**CITY OF CHESTERFIELD
PLANNING AND ZONING COMMITTEE MEETING
THURSDAY, FEBRUARY 8, 2007
CONFERENCE ROOM 101
5:30 P.M.**

RE: **P.Z. 5-2005 Winter Wheat Place (Dollar Building Company):** a request for a change of zoning from "NU" Non-Urban District to E-One Acre for a 4.0 acre tract of land located on Winter Wheat Road, 3000 feet southeast of the intersection of Wild Horse Creek Road and Long Road. (18U220092)

DATE: JANUARY 17, 2007
TO: CITY OF CHESTERFIELD PLANNING COMMISSION
FROM: ANNISSA G. MCCASKILL-CLAY
RE: P.Z. 5-2005 WINTER WHEAT PLACE ROAD SYSTEM

8. Clarify the subdivision map. Explain the map section surrounding area "129" where the City boundary line is.

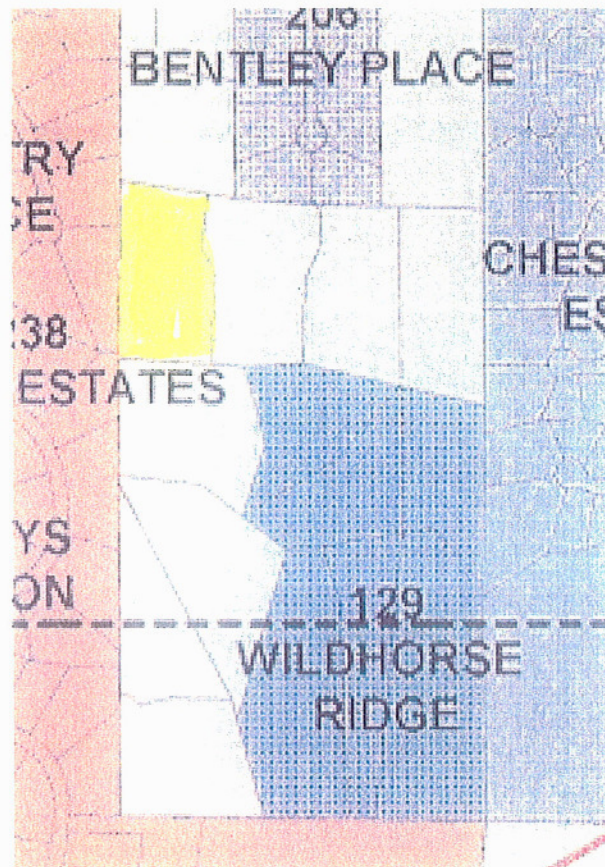
- ♦ What does "129 Wildhorse Ridge" stand for?
- ♦ Research whether "Wildhorse Ridge" refers only to the areas over "129".
- ♦ What do the dotted lines denote on the map?

Petitioner's Response:

8. Clarify the subdivision map. Explain the map section surrounding area "129" where the City boundary line is.

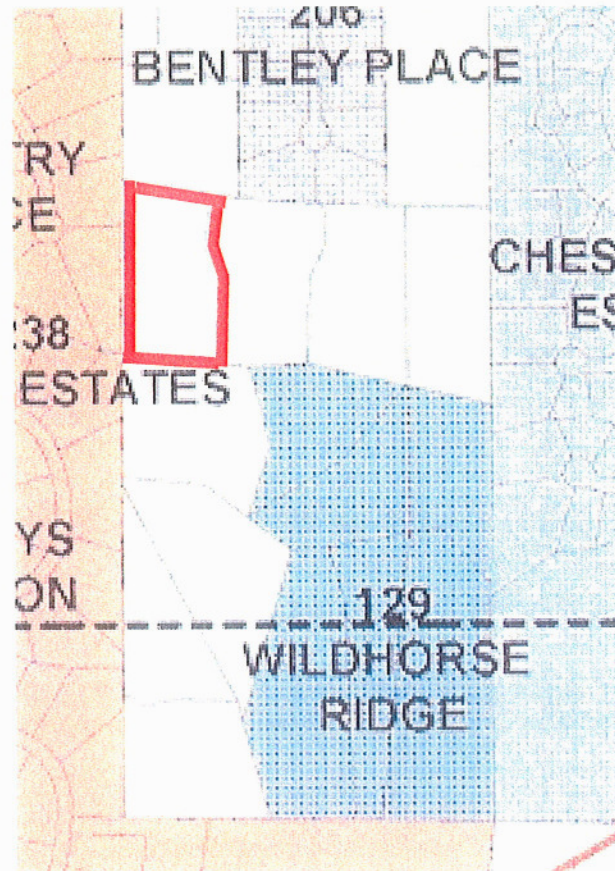
- ♦ What does "129 Wildhorse Ridge" stand for?
- ♦ Research whether "Wildhorse Ridge" refers only to the areas over "129".
- ♦ What do the dotted lines denote on the map?
